Riverside Medical Office Build-Out

ARCHITECT / GC REVIEW STAMP

BREAK ROOM 118 CASEWORK & QUARTZ COUNTERTOP PLAN, ELEVATIONS & SCHEDULE

BREAK ROOM 118
COUNTERTOP & CASEWORK
DETAILS & SLAB LAYOUT

1 COUNTERTOP & CASEWORK PLAN - BREAK ROOM 118

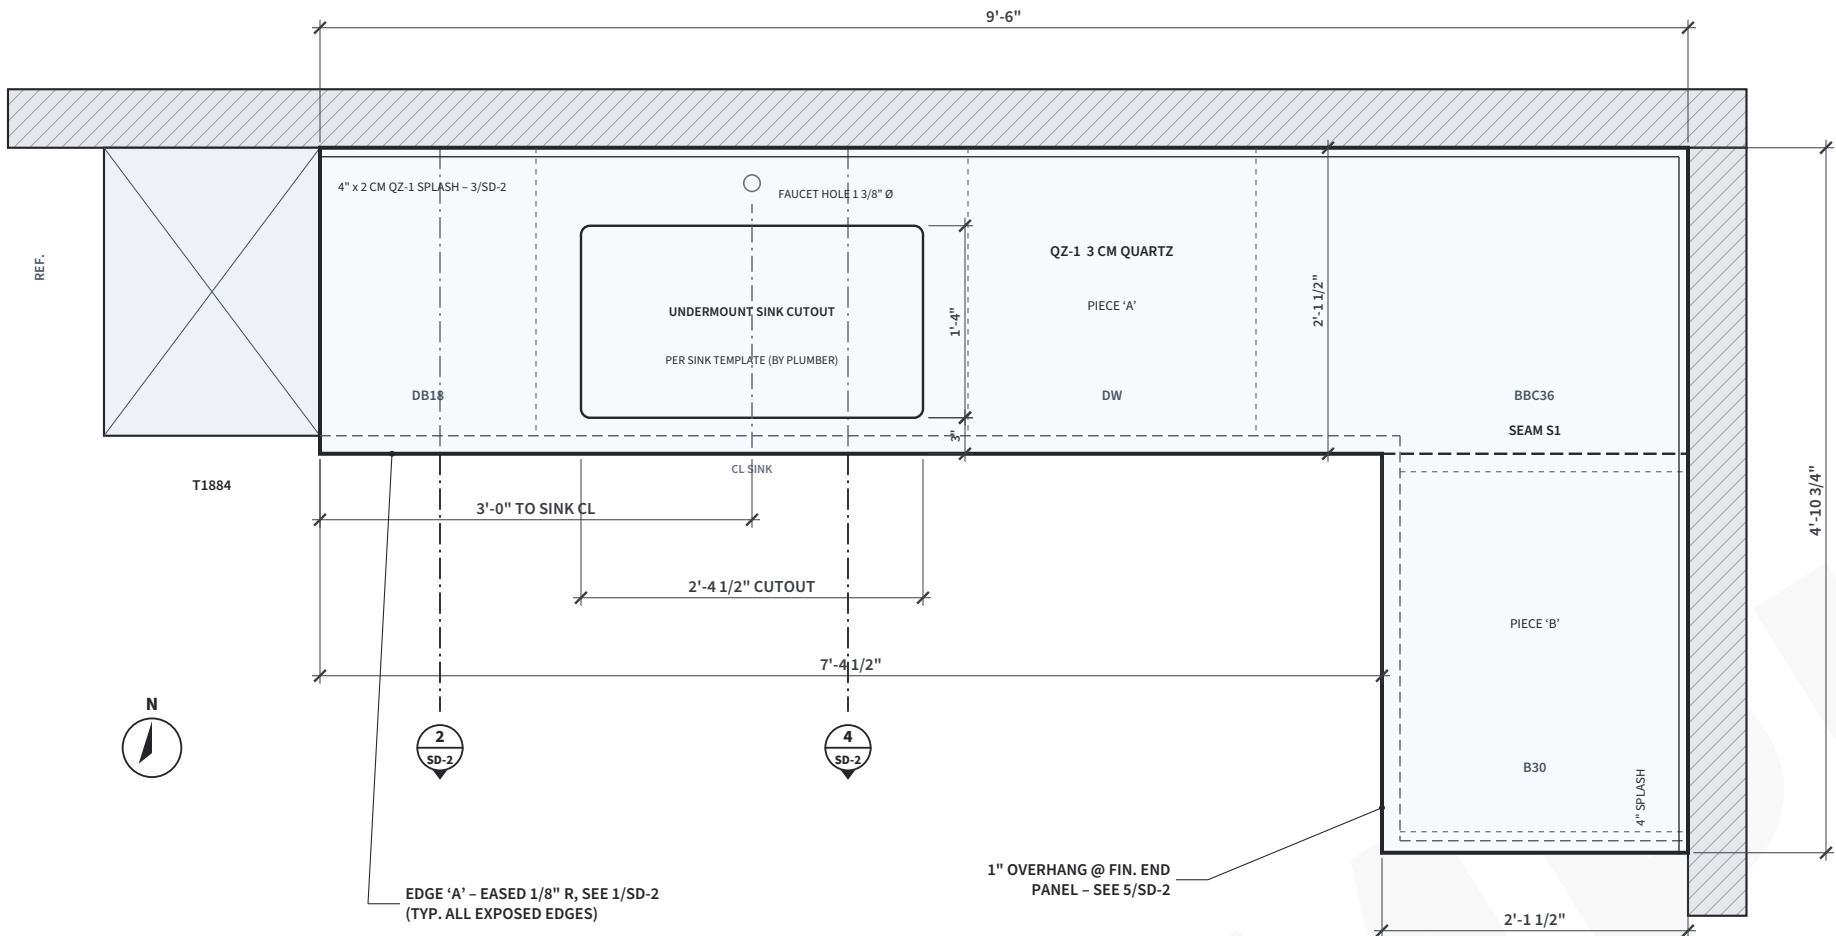
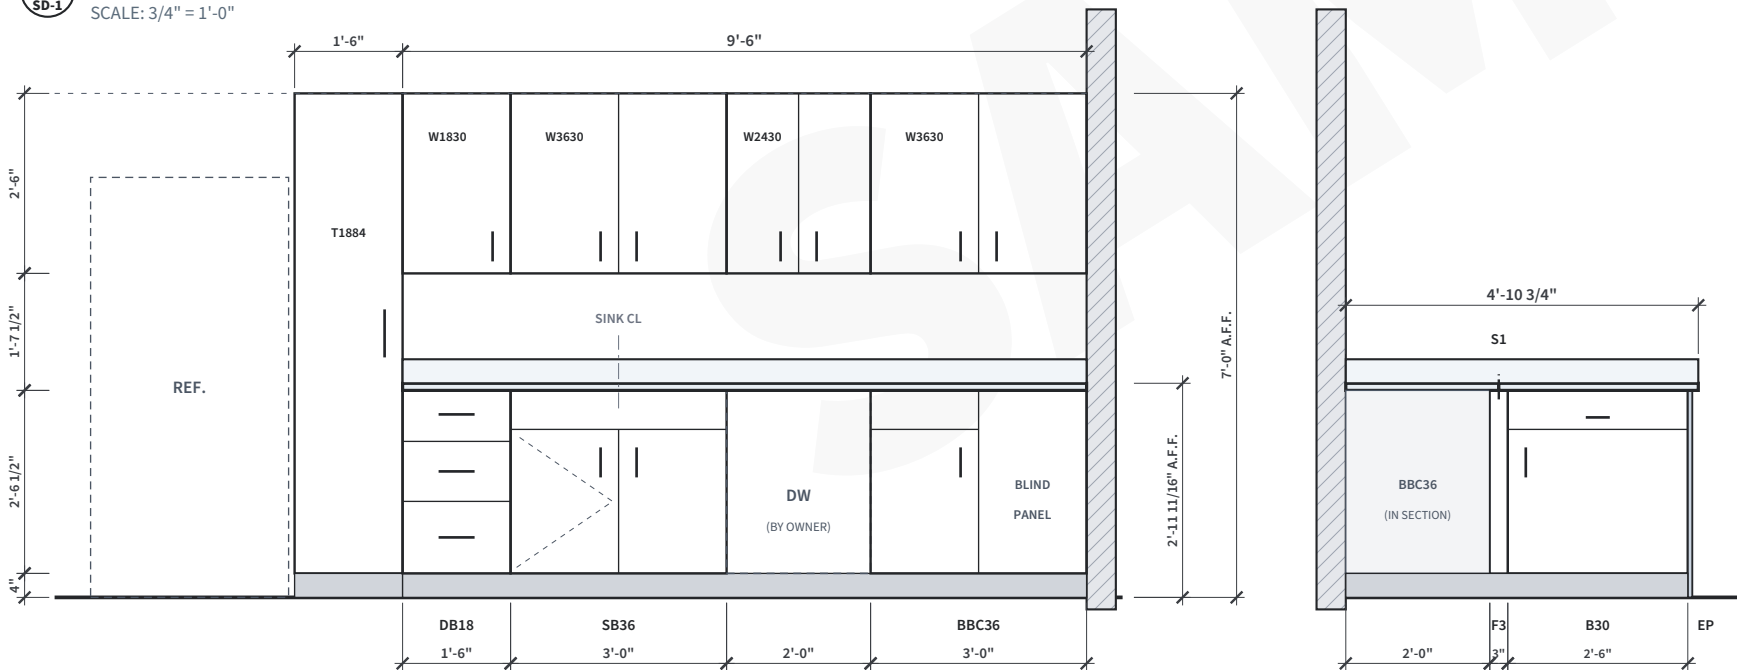
P. Nair, Lumen Architecture Studio - 10/02/26
Note: verify sink CL at rough-in (see Rev 1).

- All dimensions field verified 10/05/26 after drywall finish. Do not scale drawings.
- Countertop: QZ-1 3 cm, polished; exposed edges eased 1/8" R. Max overhang w/o support 10".
- Seams: 1/16" max, color-matched epoxy, min. 6" from cutouts. Seam S1 at inside corner.
- Undermount sink & faucet by plumbing sub; cutout per manufacturer template (on site 11/06).
- Casework: AWI Custom grade. PL-1 exterior, white TFM interior, 3 mm PVC edge.
- Base cabinets 34 1/2" H on separate 4" toe kick; wall cabinets 12" D, bottom at 54" A.F.F.
- Wall blocking by GC: 2x8 continuous at 32"-36" and 52"-86" A.F.F.
- Rev 2: per architect review - confirm DW opening 24" clear; sink CL 3'-0" from tall cab.

4 **UNDERMOUNT SINK SECTION**
SD-2 SCALE: 1 1/2" = 1'-0"

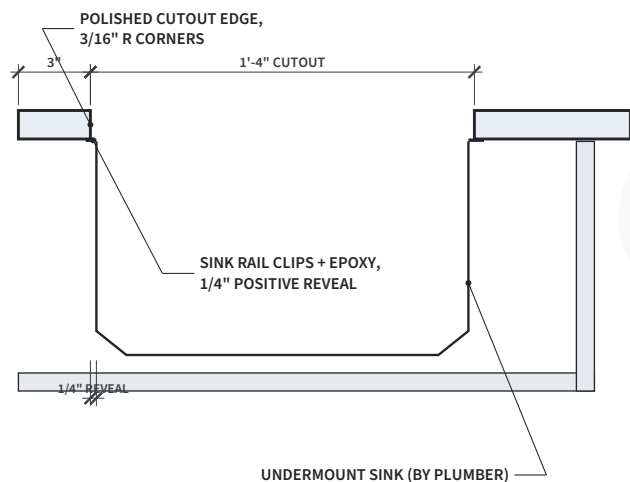
P. Nair, Lumen Architecture Studio – 10/02/26
Note: verify sink CL at rough-in (see Rev 1).
